MONTGOMERY PLANNING AND ZONING COMMISSION AGENDA
REGULAR MEETING OF MONDAY, OCTOBER 24, 2016, 6:00 P.M.
CITY HALL COUNCIL CHAMBERS 101 OLD PLANTERSVILLE ROAD,
MONTGOMERY, TEXAS.

Re: Plat Review (Preliminary)
Lake Creek Village, Section Three
City of Montgomery

Lake Creek Village, Section Three
The City of Montgomery

PRELIMINARY PLAT LAKE CREEK VILLAGE SECTION THREE

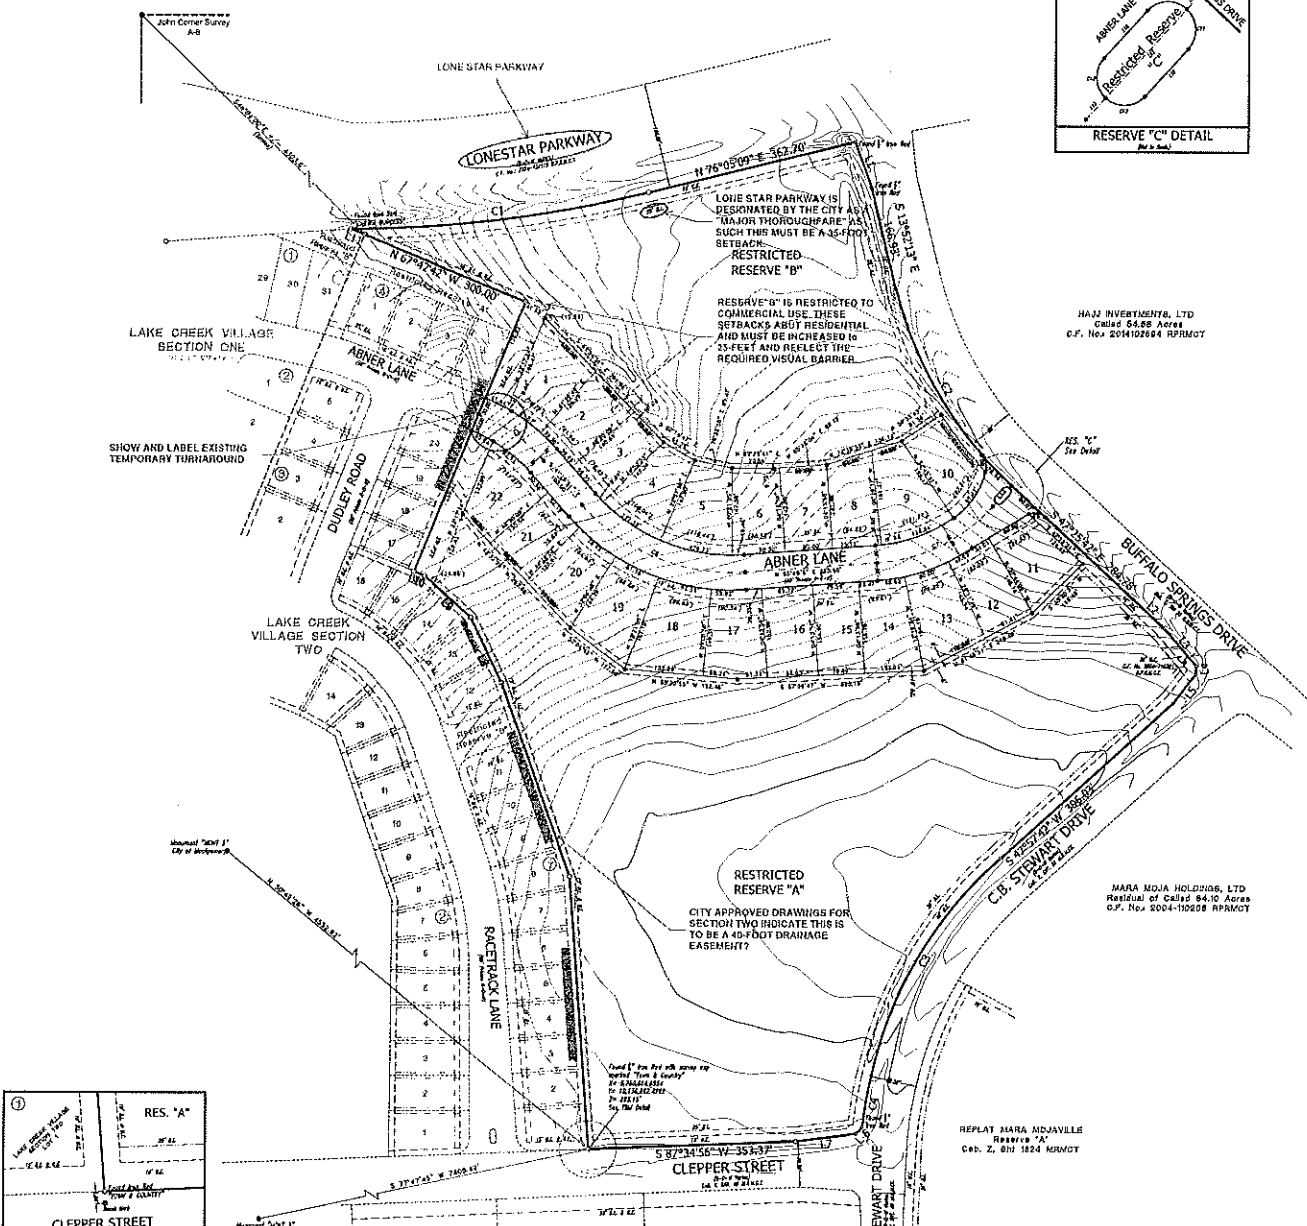
- a. There shall be a side yard on each side of the lot having a width of not less than ten-feet (10'). Clarify this is the intent per Note No. 6.
Addressed: Yes ___ No ___ Comments _____

- b. Lone Star Parkway is designated by the City as a "Major Thoroughfare". As such Reserve "B" requires a of 35-foot building setback.
Addressed: Yes ___ No ___ Comments _____

- c. Reserve "B" is restricted to commercial use. As such setback which abut existing residential in Section Two and proposed residential in Section Three must be 25-feet and note the required visual barrier.
Addressed: Yes ___ No ___ Comments _____

- d. City approved plans for Section Two indicate western boundary Reserve "A" is to be platted as a 40-foot Drainage Easement.
Addressed: Yes ___ No ___ Comments _____

- e. Show and label existing temporary turnaround as shown in City approved drawings for Section Two.
Addressed: Yes ___ No ___ Comments _____

CLARIFY: THERE IS TO BE A 10-FOOT SETBACK ON EACH SIDE OF A SIDE LOT LINE.

- PROVIDE A COVER SHEET WHICH INCLUDES ALL NECESSARY DEDICATORY LANGUAGE, SIGNATURE BLOCKS, ETC.
- PROVIDE TITLE LETTER OR TAX CERTIFICATE AS DEFINED IN SEC. 78-02(f) OF THE CITY'S CODE OF ORDINANCES.
- PLEASE VERIFY SUBMISSION OF REQUIRED PRELIMINARY PLAT FEE.
